AIRWORTHINESS DIRECTIVE - GLIDERS

GFA/AD 91 EIRIAVION OY 8

Types Affected: All PIK 20 Series.

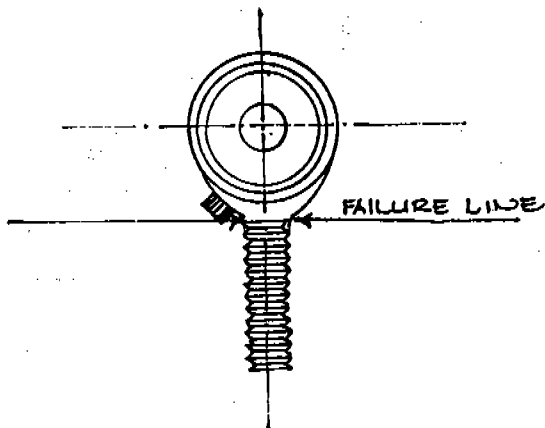
A Pik 20D currently under repair following a crash was found to have a cracked elevator rod ball end fitting that failed completely when the aircraft crashed.

The fitting appeared to be suspect in manufacture and is currently undergoing tests at A.R.L. and C.A.C.

Before further flight remove elevator and rudder fittings and subject them to an optical examination for cracks using a powerful magnifying glass. In particular check the upper extremity of the thread.

The diagram below illustrates the fitting and the area where it failed.

Should your aircraft be subject to a heavy landing this area must be checked thoroughly for evidence of failure.
